From: Joseph O'Neill [joneill@jonesedmunds.com]
Sent: Tuesday, August 22, 2006 3:42 PM
To: Pelz, Susan
Cc: Joseph O'Neill; Richard Siemering; Carlos Restrepo
Subject: Section 8- Leachate Pipe Profiles

HILLSBOROUGH COUNTY
SOUTHEAST COUNTY LANDFILL
SECTION 8 SITE A
LEACHATE PIPE SETTLEMENT CALCULATION
FIGURE 1. SITE PLAN

Subject: Response to Request for Additional Information
Southeast County Landfill, Hillsborough County
Capacity Expansion Section 8
Certification of Construction Completion
Permit No. 35453-009-SC
Jones Edmunds Project No. 08449-020-01

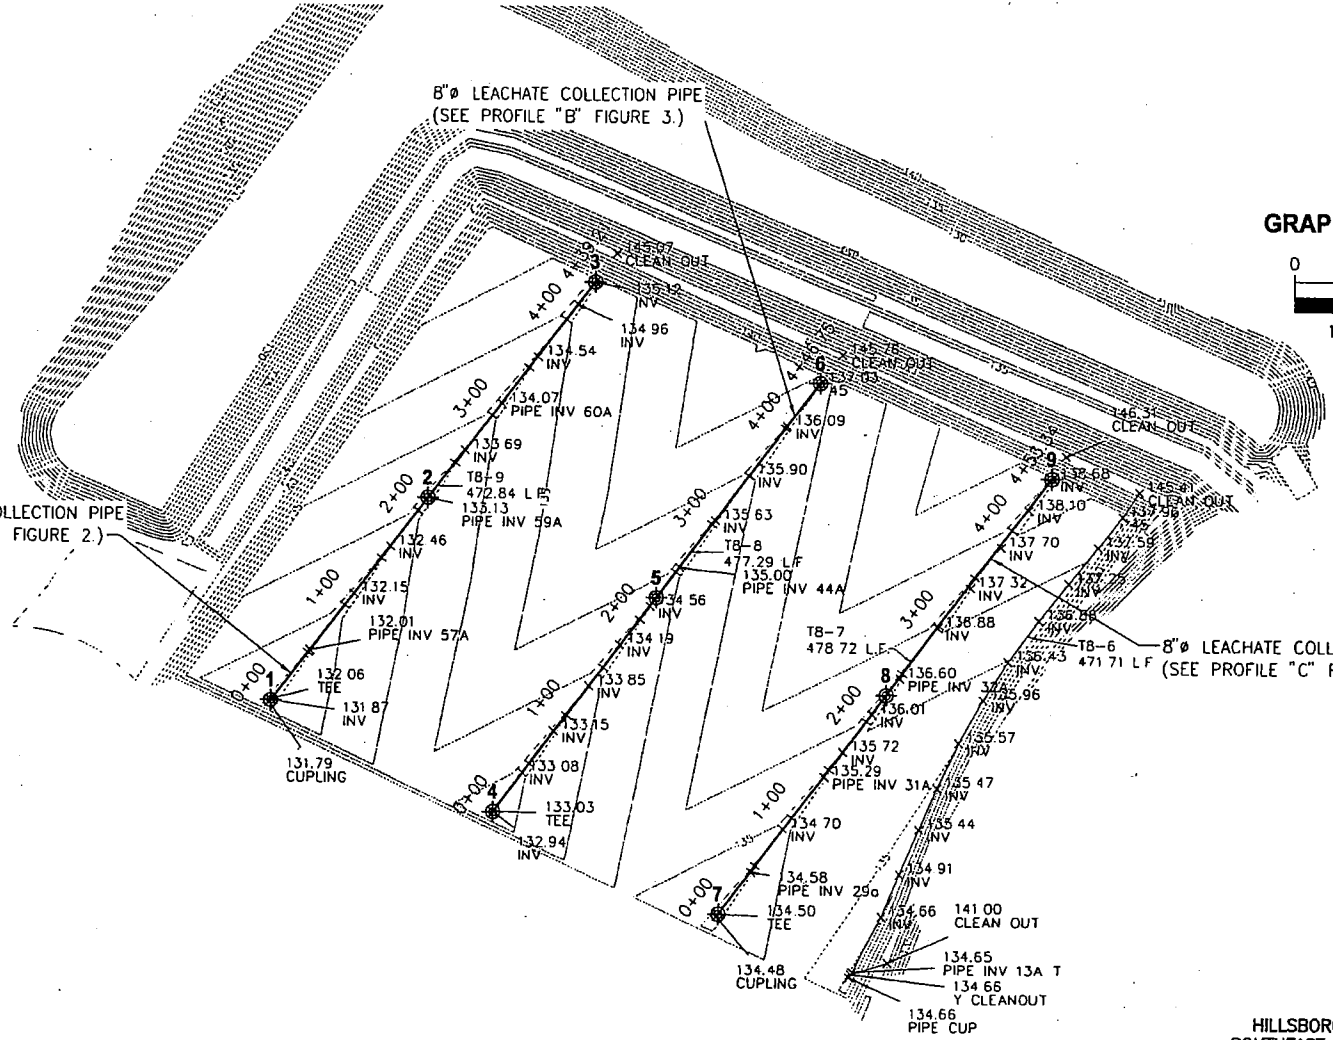
The as-built pipe survey has numerous individual elevations and we have an exaggerated vertical scale shown on the profile hence the "wavy" profile. We only have three settlement points (as shown on the Sec8Pipe Profiles.pdf). We connected the three points with straight lines therefore there may be places in between the post-settlement points where the settled profile has the "appearance" of being "above" the initial as-built pipe profile.

Per our conversation yesterday, I checked the pipe profiles to make sure that the as-built pipe elevations were used as a starting reference elevation. They are. (refer to Sec8Pipe Profiles calcs.pdf)

From the as-built elevations, the settlement numbers computed by SCS Engineers were used to determine the post-settled elevation for Section 7&8 Buildout and Site "A" Buildout.

ATTACHMENT 1
Revised Primary and Secondary As-Built Panel Layouts

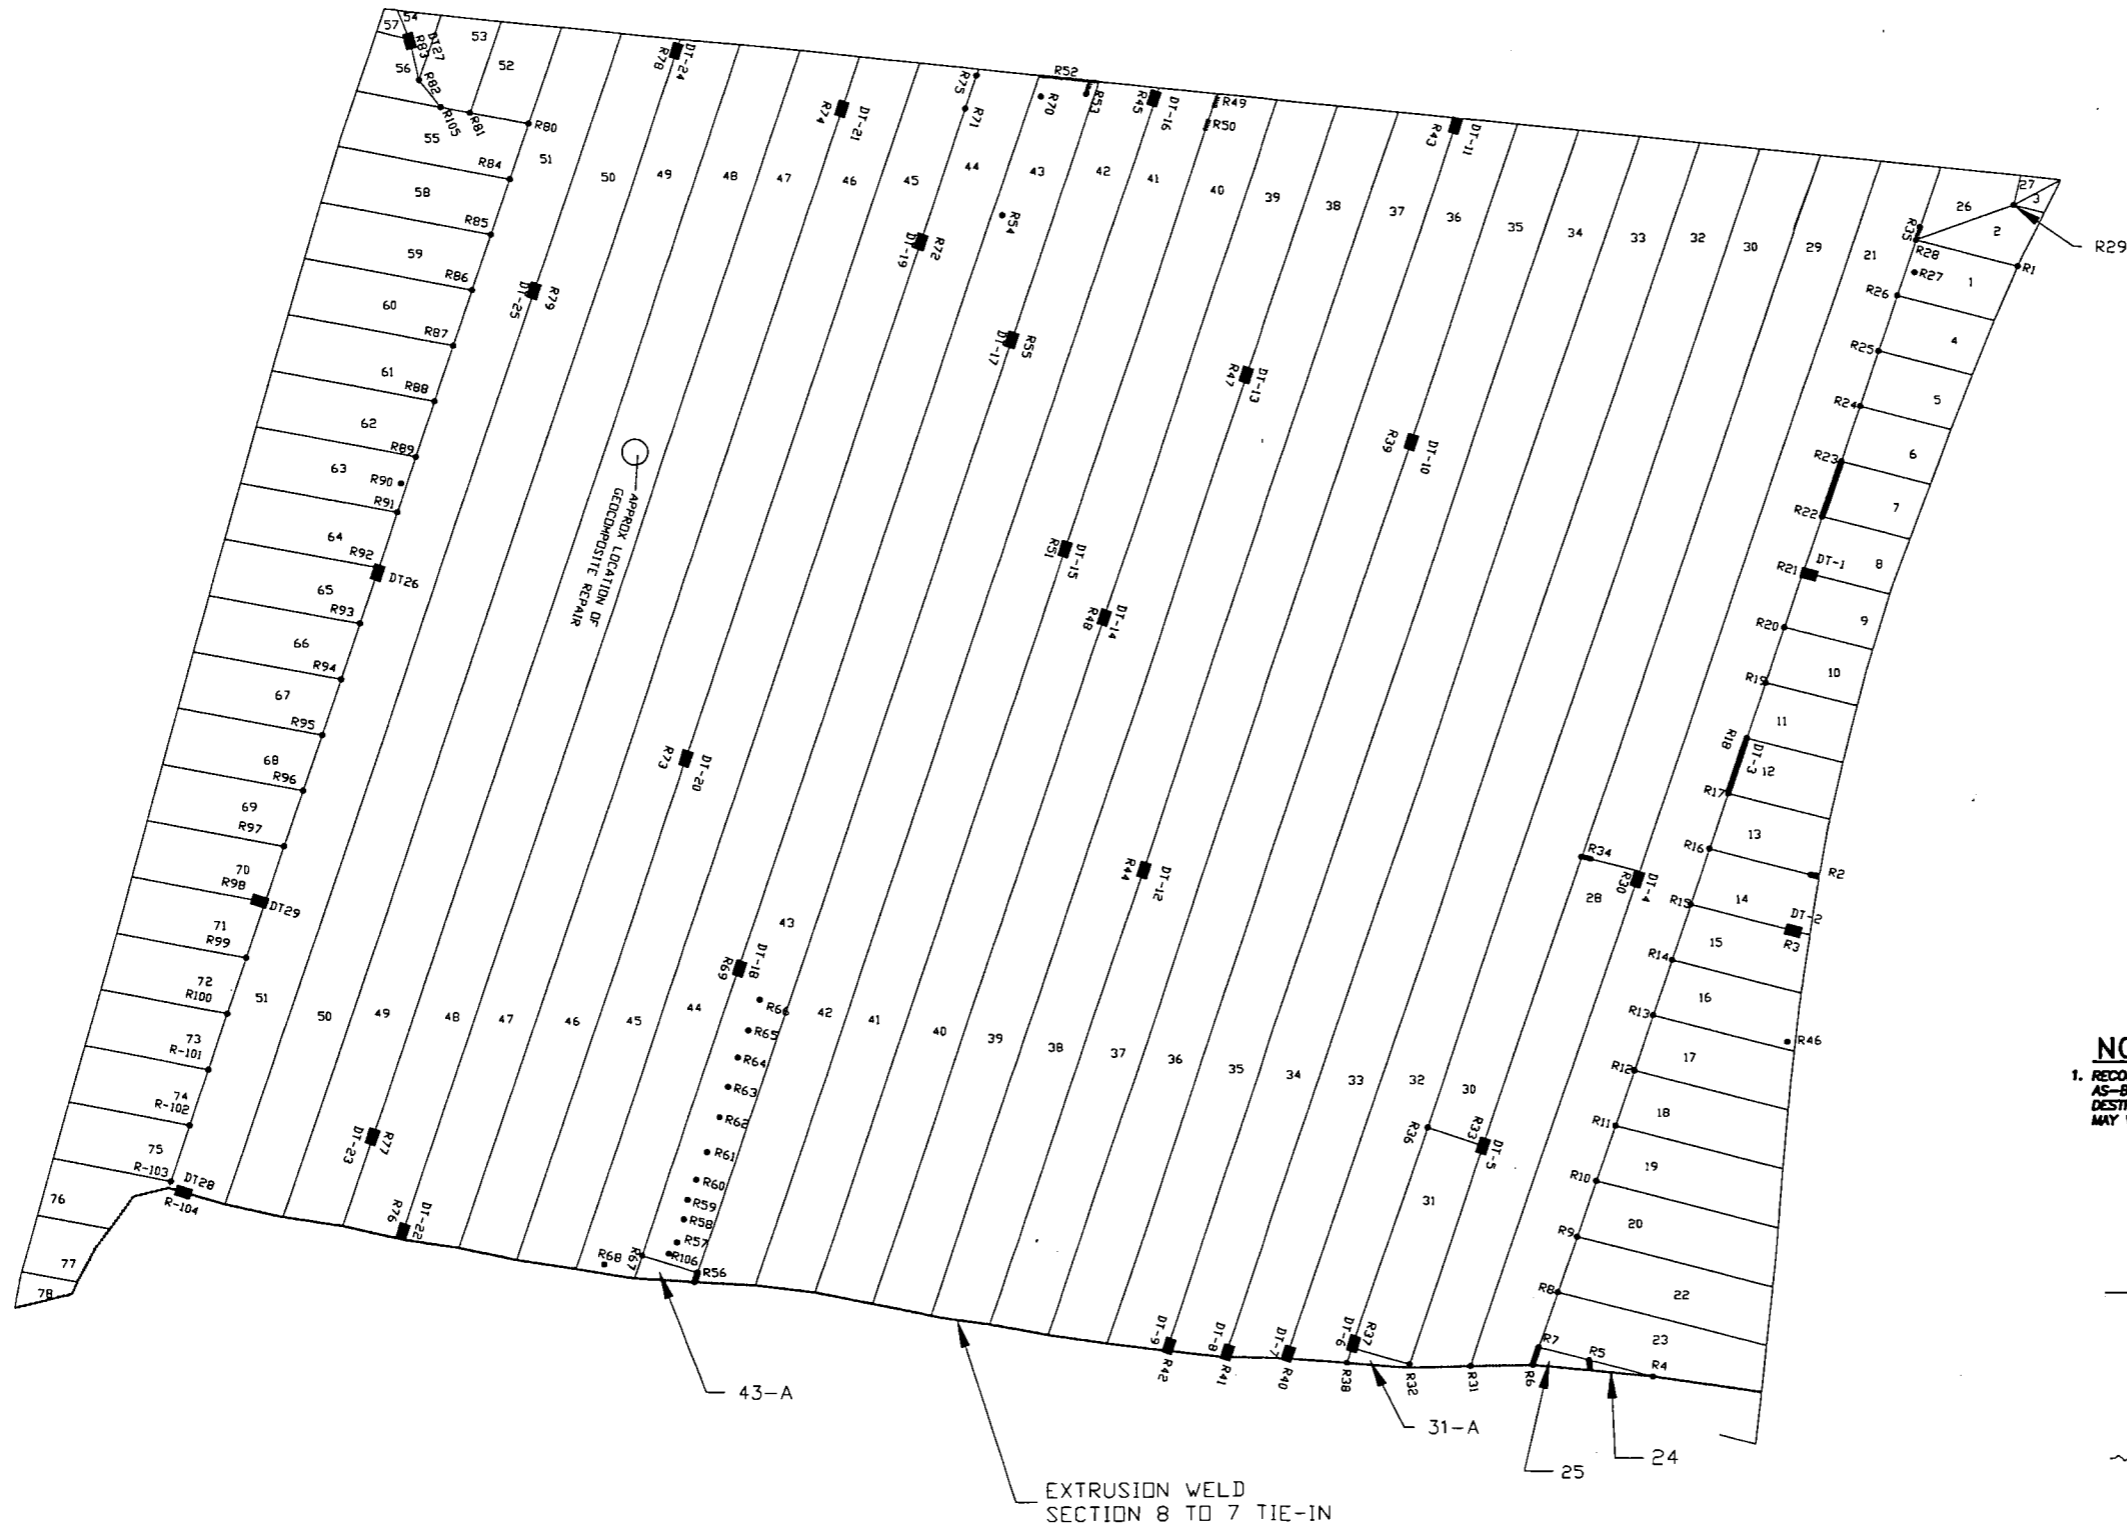
Comment 2) Please provide a revised Geomembrane Panel Layout that shows the "tear" mentioned in the field notes on the primary geomembrane panel layout. The "tear" was mistakenly placed on the secondary panel layout (Refer to the Department Comment Number 3.c.4) .

Comment 5) The "cap" repair is shown on the northend of the Panel 27/28 does not have a repair number. Please clarify if the repair is actually on Panel 27/28. If present, please provide a repair number, repair logs, or a revised Geomembrane Panel Layout.

Response 2: A revised Geomembrane Panel Layout is provided in Attachment 1 with the corrected location of the geocomposite "tear".

Response 5: We have reviewed the repair logs, non-destructive logs, and coordinated with the QES Field QA technician and it appears that Repair No. 44 was mistakenly placed in the wrong location on the as-built panel layout drawings. Repair No. 44 (identified as "CAP") should have been placed on the north end of seam 27/28. A revised secondary panel layout drawing is provided in Attachment 1.

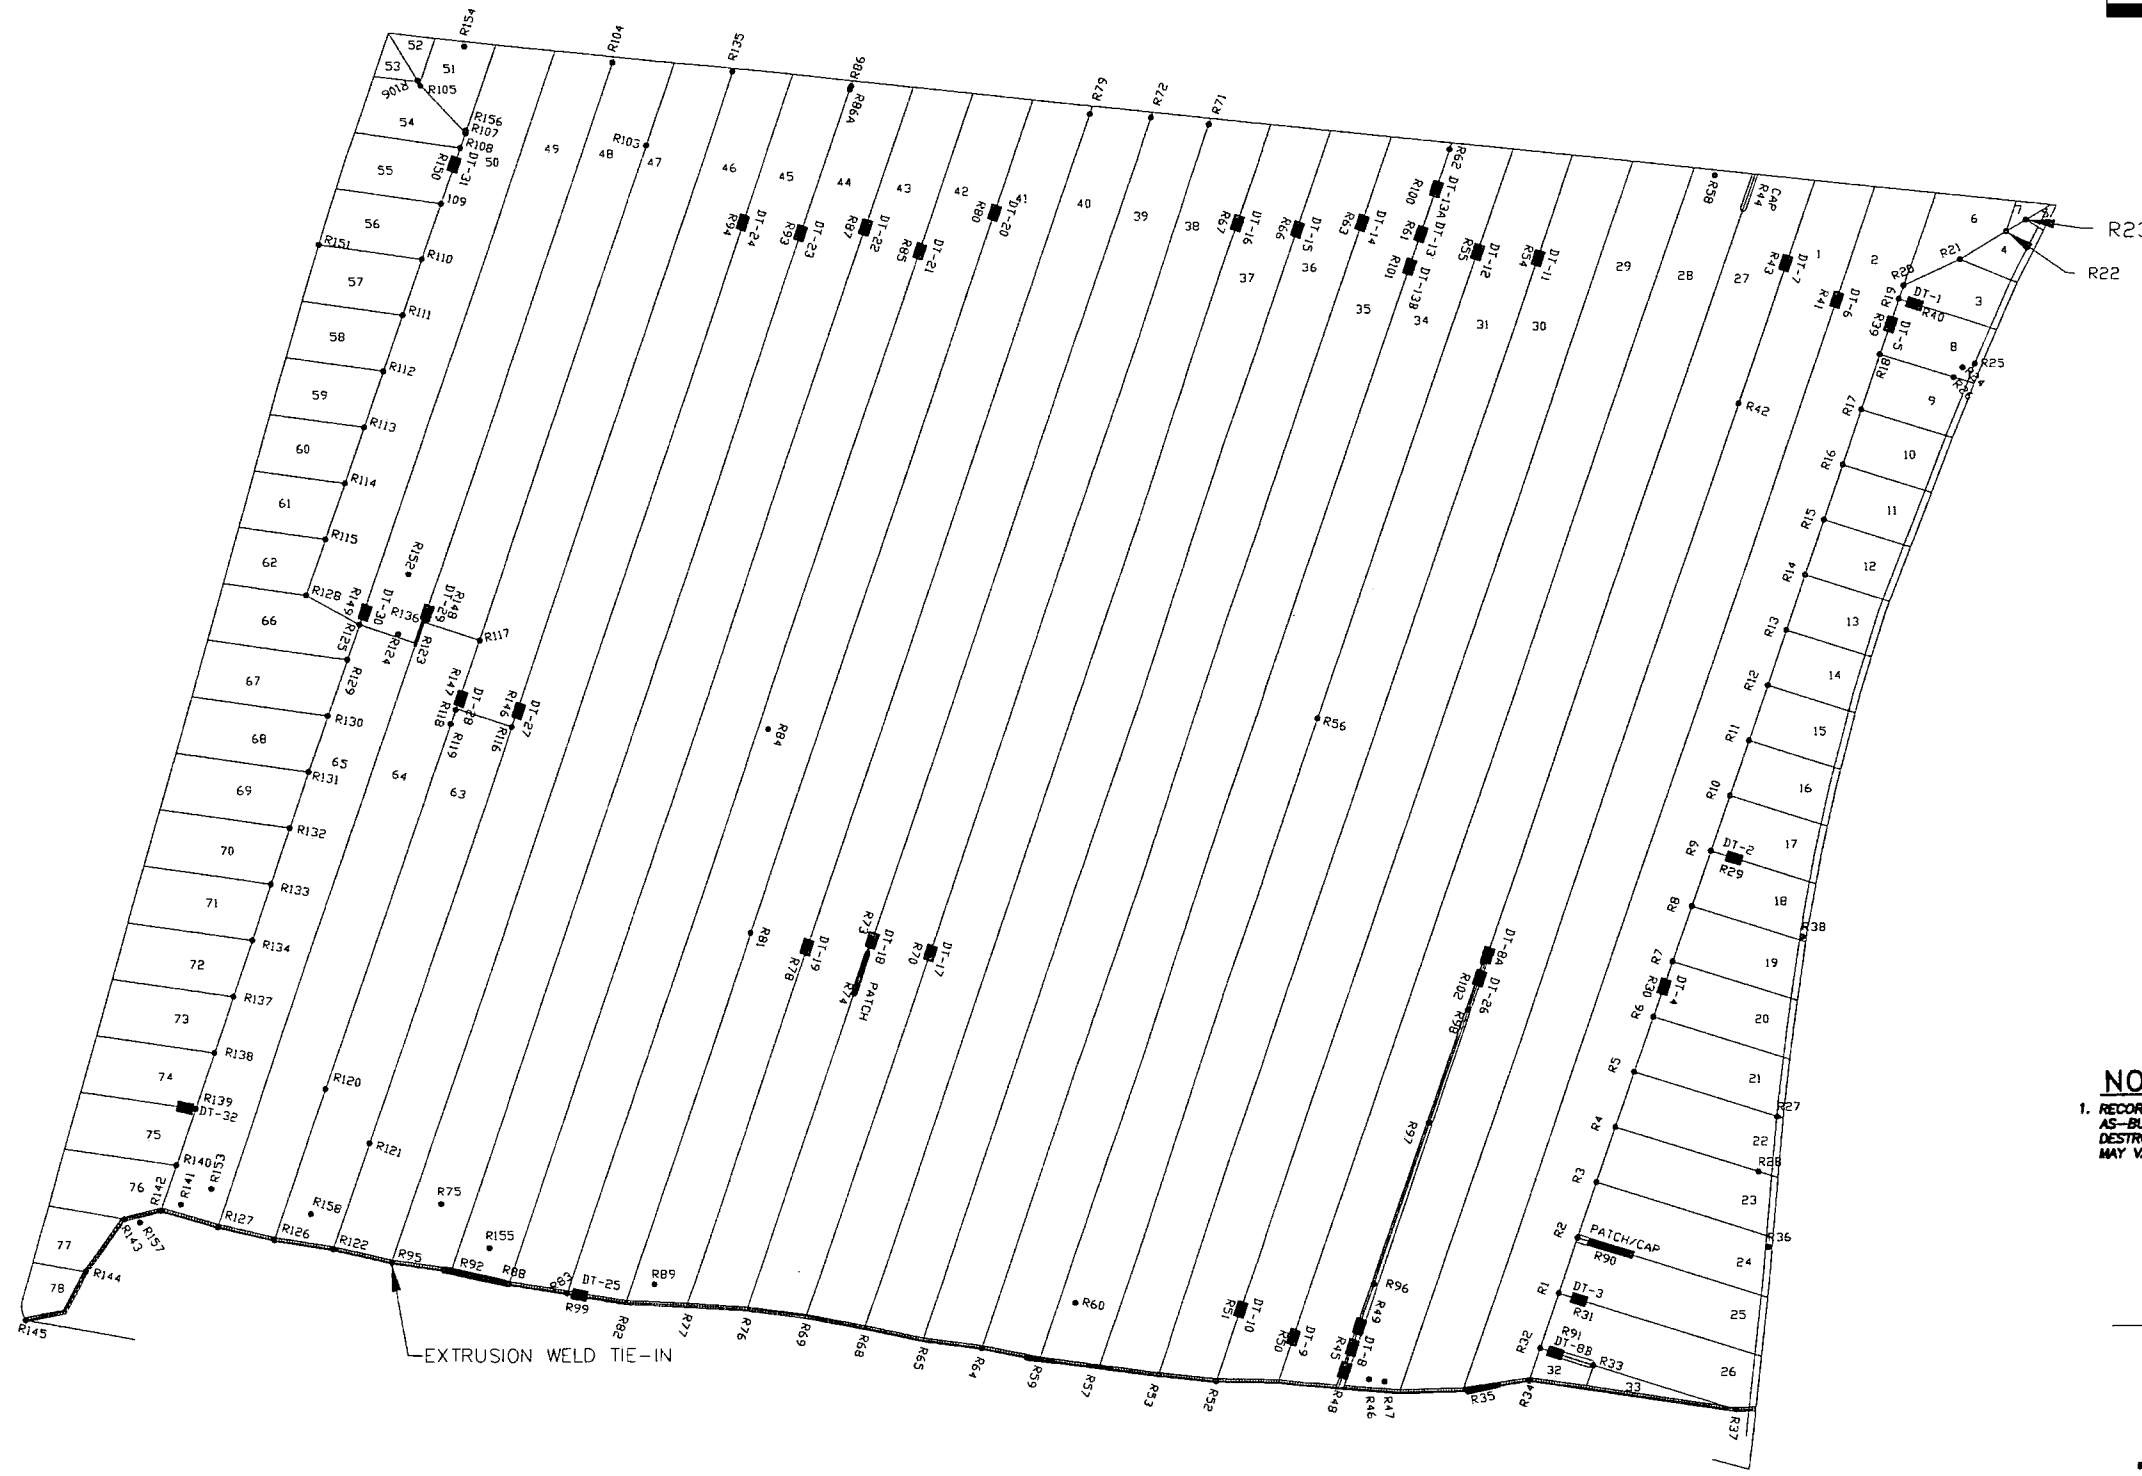
Comment 1) Please clarify the photograph dated November 3, 2005. (Refer to the Department's Comment Number 3.C.4).

Response 1: As discussed during the meeting, no damage was observed to the primary geomembrane as shown in the submitted photographs; however, the location of the damaged geocomposite was mistakenly placed on the secondary as-built panel layout. Provided in Attachment 1 is a revised Primary As-Built panel layout that shows the damage location (approximately over Primary Panel 48).

Also included in Attachment 1 is a revised Secondary as-built panel layout that was included to provide clarification or answer others comments.
